Access Compliance Report Public Rights-of-Way (Pedestrian Signals)

Main Street: **HAZARD_AVE** Cross Street: **BEACH_BLVD** Location: **SE**

ADA ID: **SGRK211004143621** Signal Type: **One Push Button-APS** Overall Compliance: **No** Severity Scores: **BTN 1: 25** **BTN 2: N/A** **No BTN: N/A**

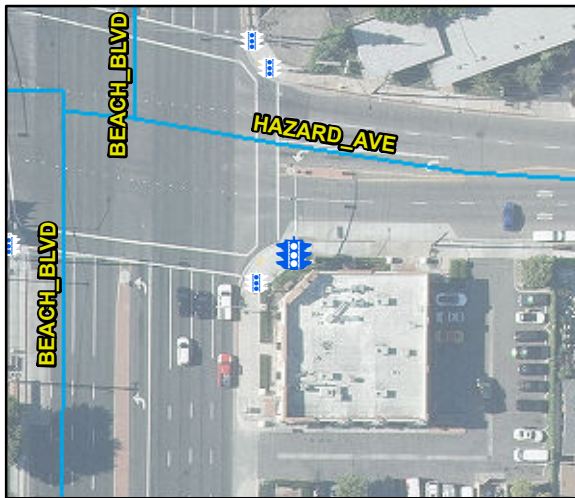
Possible Solutions: Replace Signal Push Button With APS Button. Remove & Relocate Sign.
